Wizards Workshop

TEKTRONIX INTERNAL USE ONLY

July 17, 1981
Issue 11-13

DIAGRAMS OF TYPICAL IC STAMPINGS:

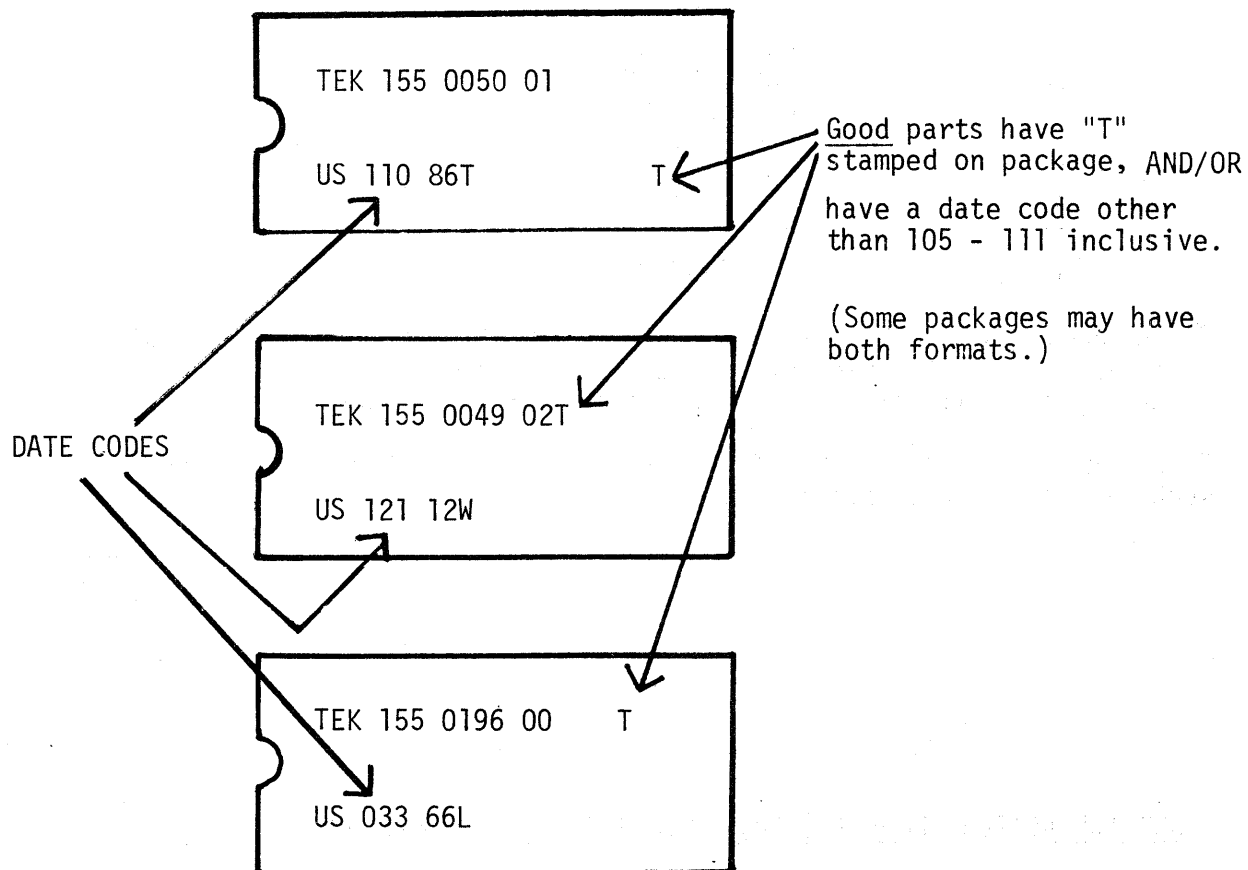
Additional reliability screens have been completed on all finished goods warehouse stock and work-in-process. Each part that passed the additional screens has been stamped with the letter "T" (see the following diagrams).

During a service call or when an instrument is at a Tektronix facility for calibration or repair, replace the part if it is date code 105-111 without a "T". The parts must be replaced with parts that have the letter "T" or with date codes other than 105 through 111 inclusive. Replace the part using failure code "155". Charge the replacement part to Warranty (Activity Code 02) or, Customer Accomodate (Activity Code 03) to Responsibility Number 2328-10. In either case, return the parts to Beaverton using the standard procedure for warranty parts.

5223, POSSIBLE VERTICAL AND HORIZONTAL OSCILLATIONS

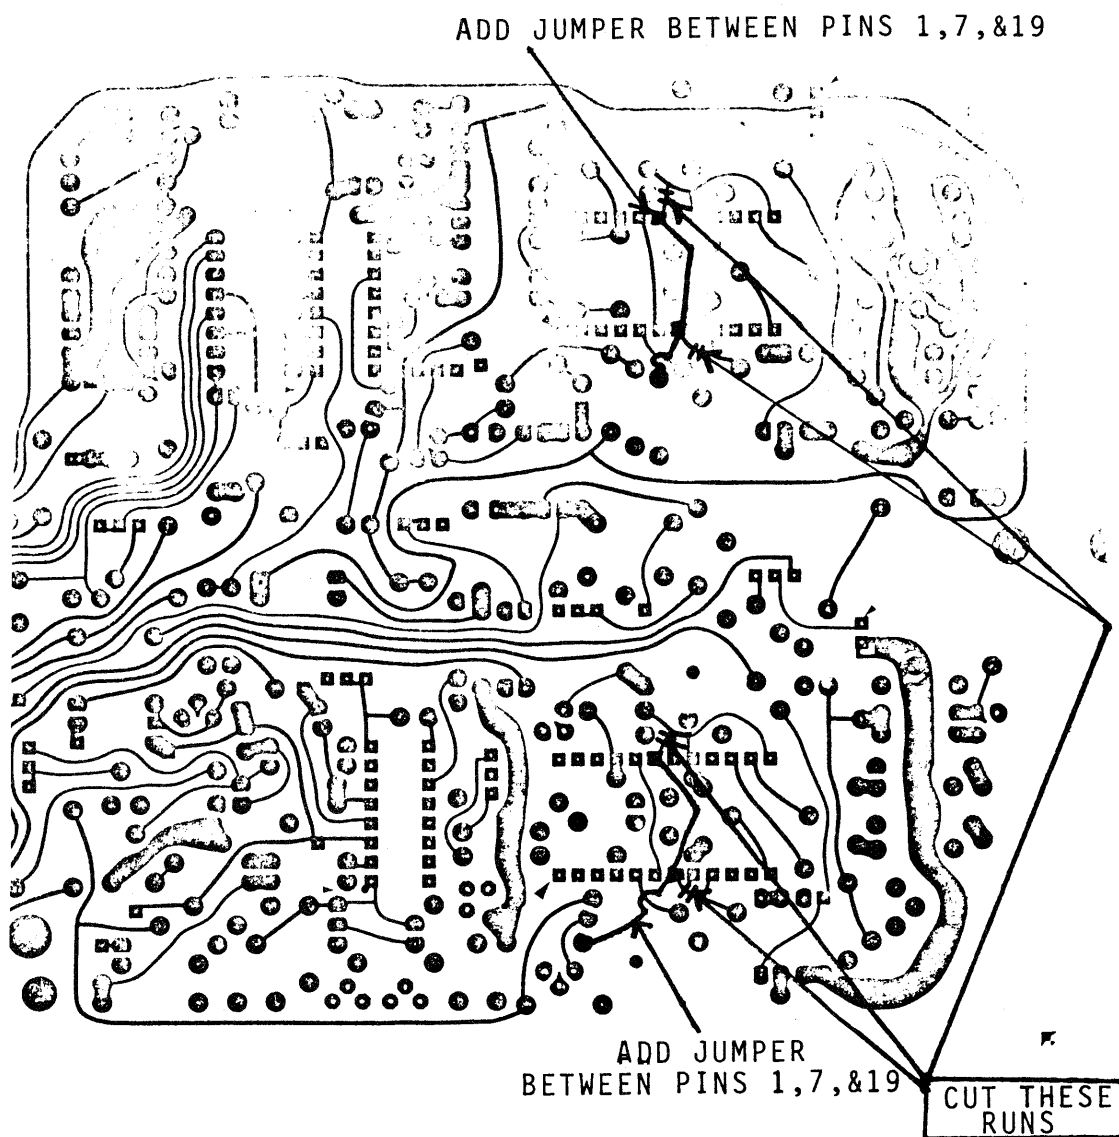
Two modifications have been made to prevent oscillations, one each to the horizontal and vertical amplifiers. Both amplifiers can, especially when cold, exhibit a low level oscillation of about 180 MHz. To cure this, the same change is being done on both output I.C.'s, U200 and U230. First remove the XYZ, A3, circuit board from the instrument. On the back of the board, cut the runs going to pins 7 and 19 of U's 200 and 230. On the back of the board run a jumper, using insulated wire between pins 7 and 19, then to pin 1 on U200, as shown on the following drawings. Perform the same strapping to U230.

AFTER MOD.

408/412 LEAD FAULT MALFUNCTION (CONTINUED)

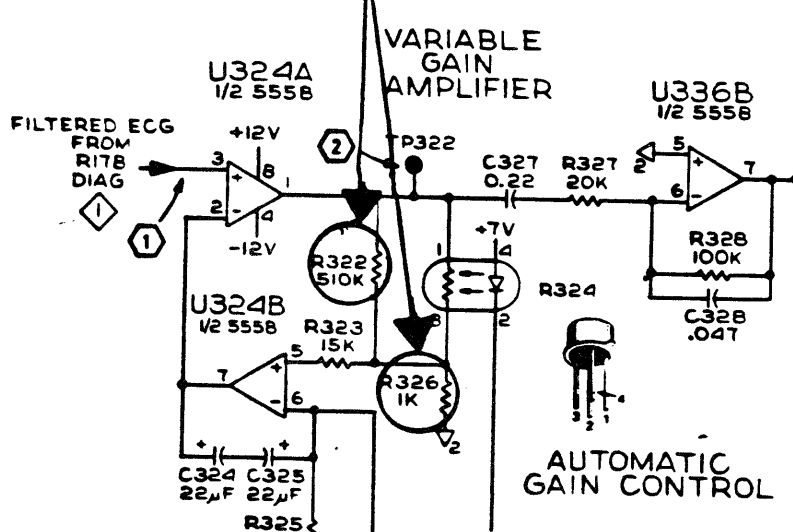
The lead fault lamp may not light on some monitors when patient leads become disconnected because the fault detection current is insufficient to compensate for leakage paths. Also, a vendor process change is producing increasingly sensitive opto-isolators (CR324) which cause the QRS detector AGC loop to overshoot during initialization. The following changes should be made to all monitors listed below as they come in for service.

Change:

R322 to 100K ohm P/N 315-0104-00

R326 to 200 ohm P/N 315-0201-00

Figure 5. Bottom view of the Field Timing circuit board showing the added transistors and resistors.

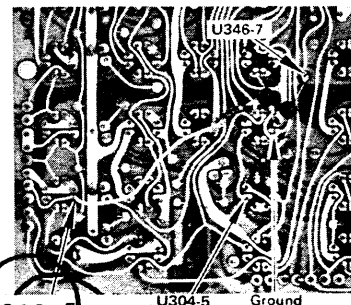
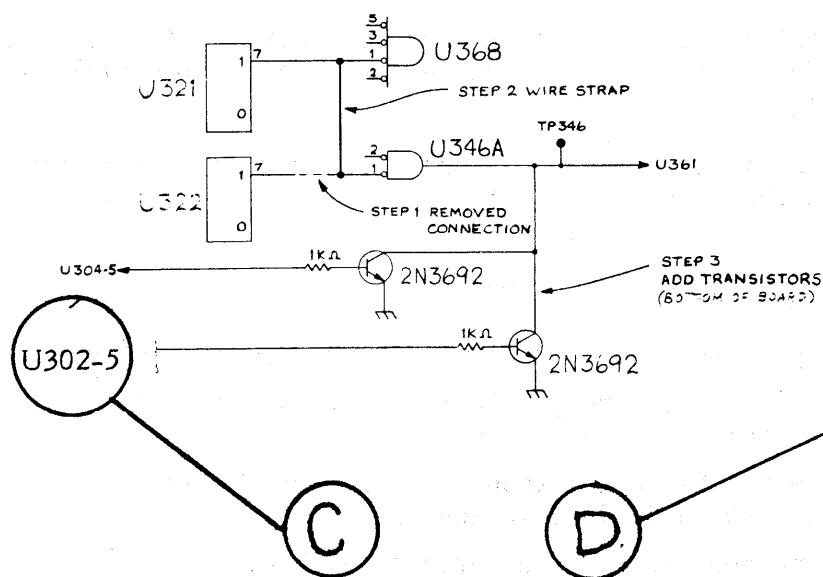
- A. H-Blanking--use only a 74LS221, a 74221 won't function correctly.
- B. The top IC ($\frac{1}{2}$ of 74LS221) has one pin that is not labeled between pins 14 and 1. It should be labeled pin 2.
- C. V-Blanking--the base of the bottom 2N3692 transistor should go through a 1K resistor to U302 pin 5 instead of pin 2.
- D. Figure 5 should be marked U302-5 in accordance with C.

DIAGRAM 'A'

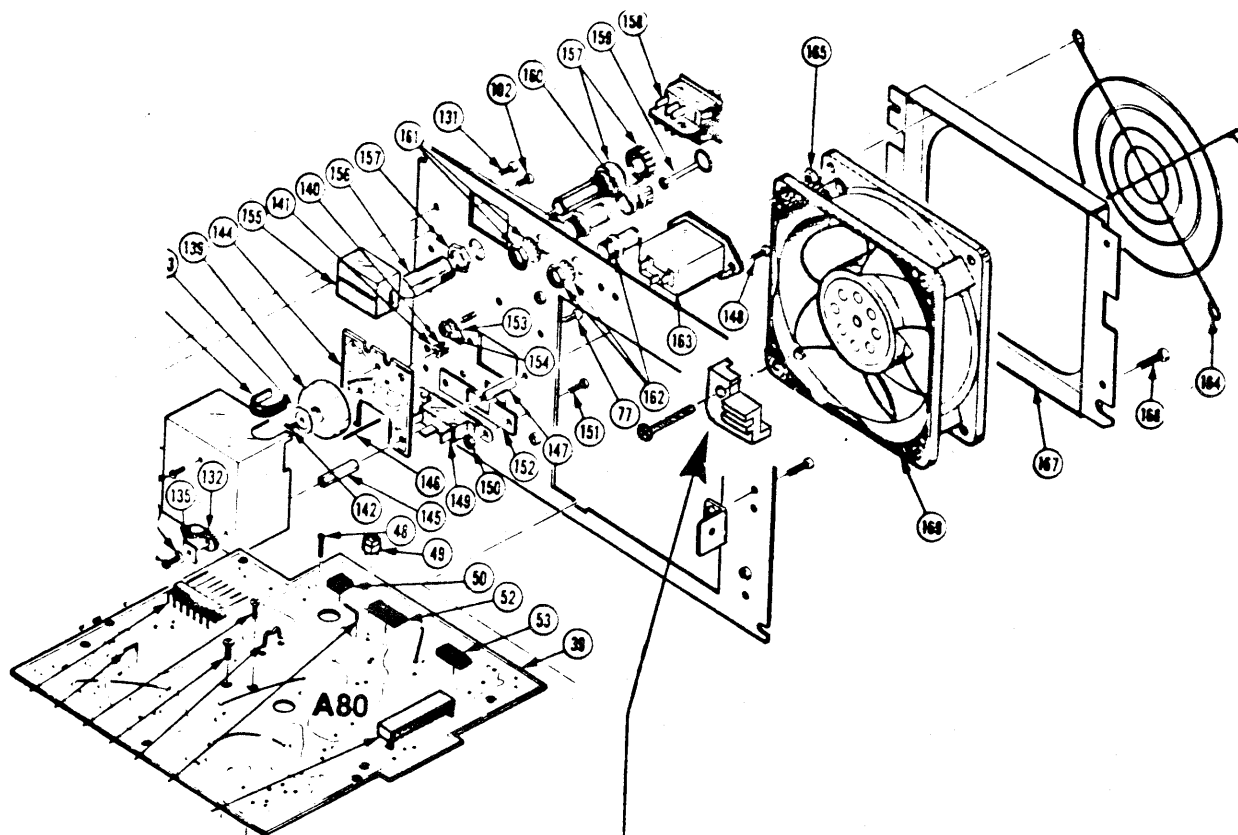
- 3) To provide added support to the rectifier circuit board add a support bracket (386-4641-00) which is attached to the fan as shown in diagram 'A'.

Add rectifier circuit board support bracket (386-4641-00), which is mounted with (1) screw (211-0523-00) and (1) nut (210-0457-00) to the fan as shown.

DIAGRAM 'B'

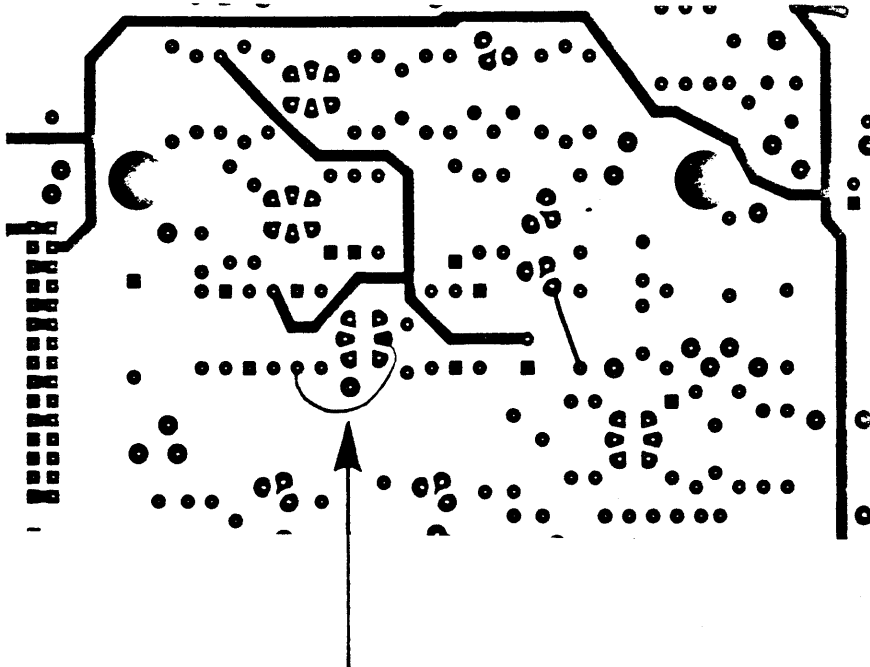
- a) support bracket - PT#386-4641-00
 - b) 1 screw - PT#211-0523-00
 - c) 1 nut - 210-0457-00
- 4) A run is missing going from CR320 to Q228 (A side) on the regulator circuit board (670-5418-01). Strap the anode of CR320 to the base of Q228 as shown in diagram 'B'. This strap changes regulator circuit board 670-5418-01 to a 670-5418-02. There is no change to the schematic diagram 33.

Strap the anode of CR320 to the base of Q228 as shown.

DIAGRAM 'C'

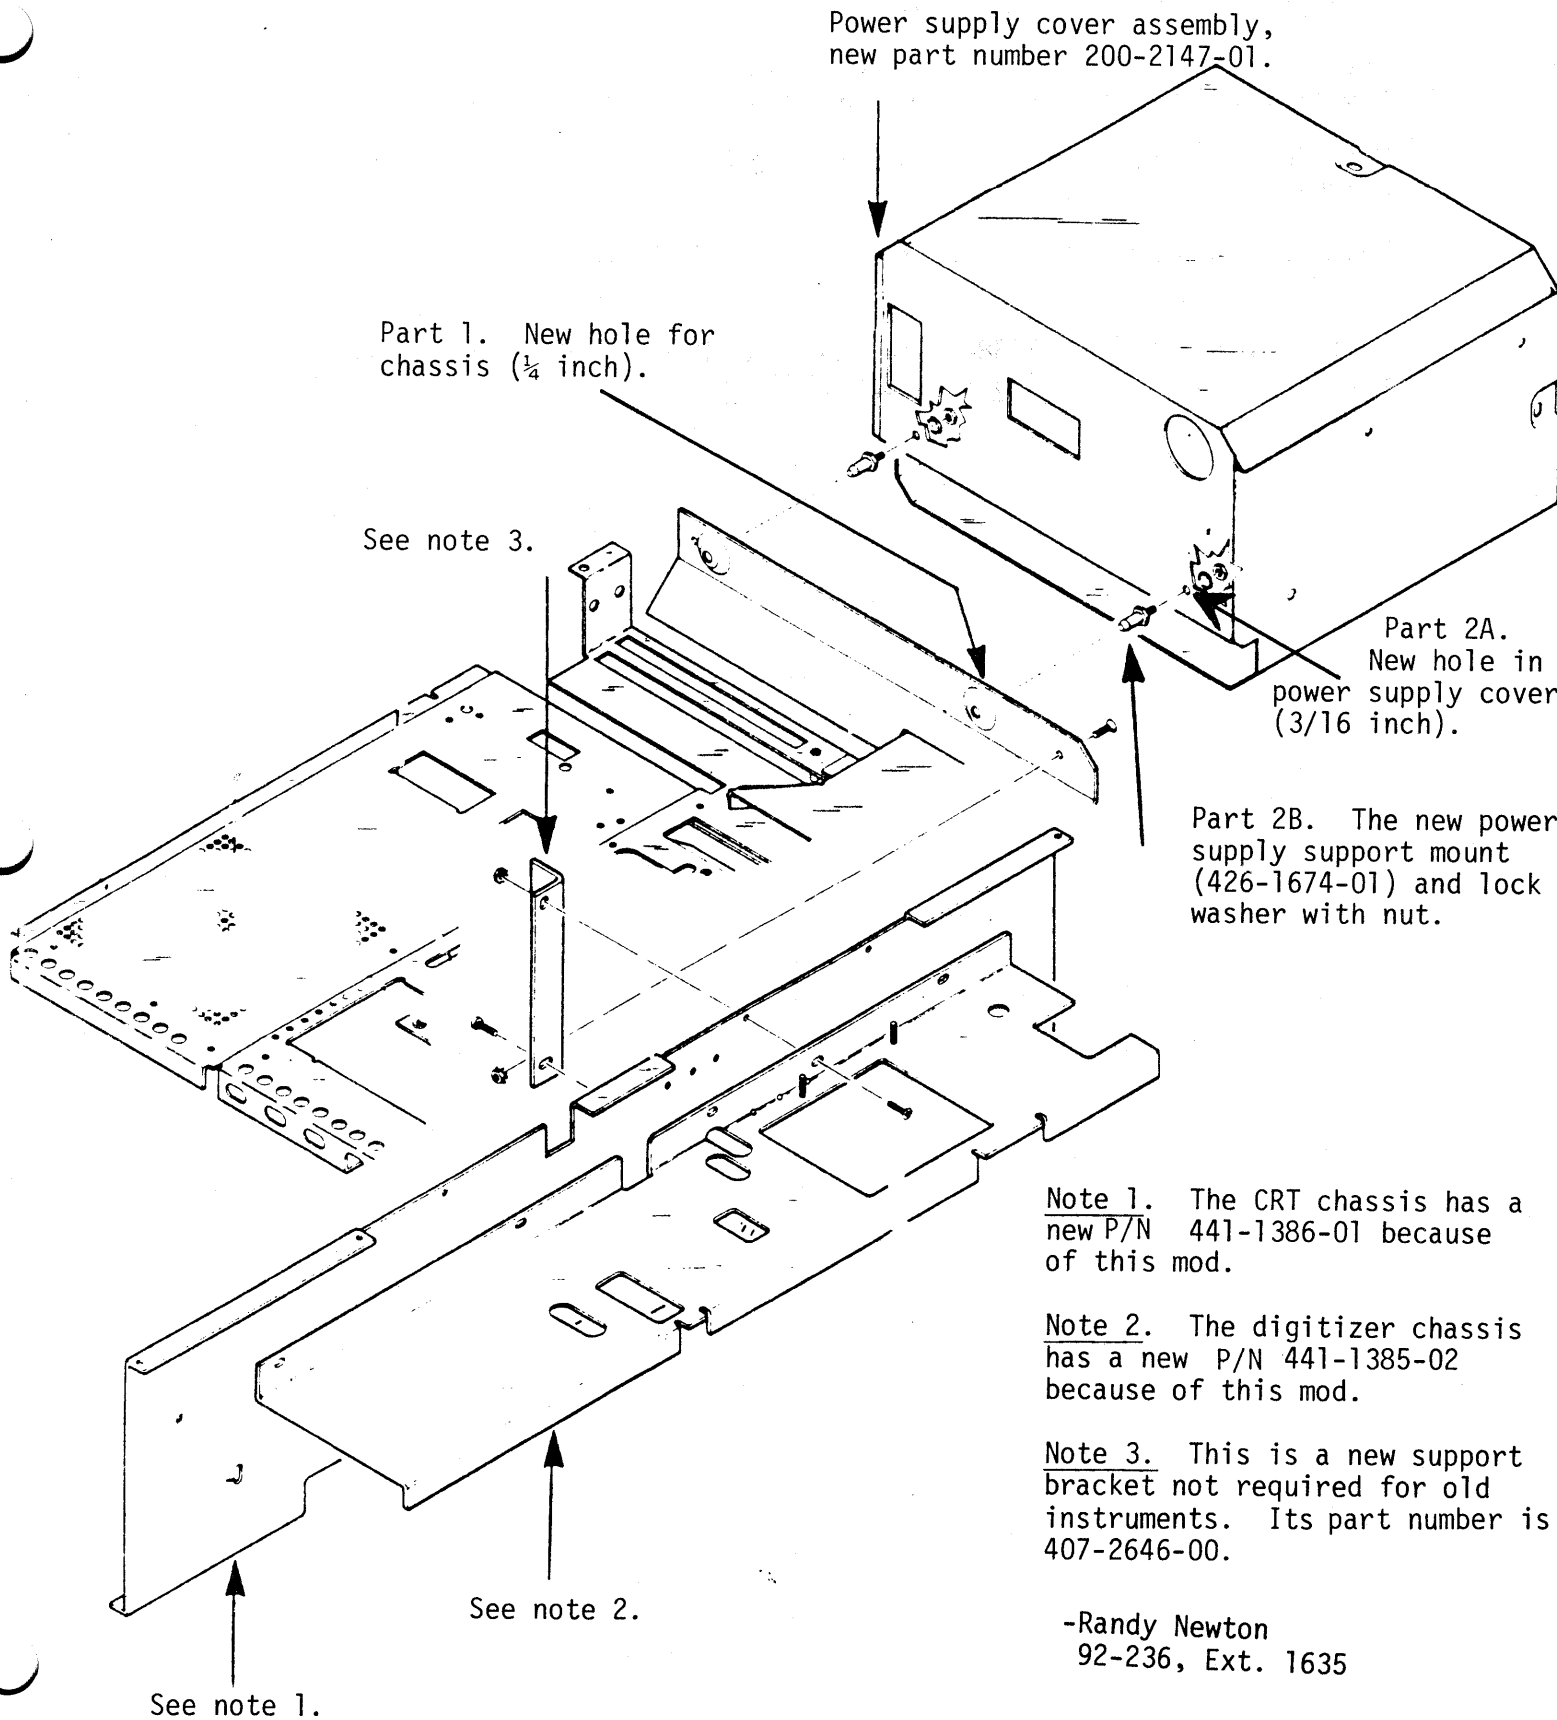
Symptom: A power supply with part number 620-0269-02 and higher will not fit into an instrument below serial number B060598. There has been an additional support mount added to the power supply cover which requires an additional hole in the chassis (refer to diagram 'A' and 'C').

(3) Referring to diagram 'C', insert the power supply support mount (P/N 426-1674-01) with lockwasher (P/N 210-0008-00) and nut (P/N 220-0555-00).
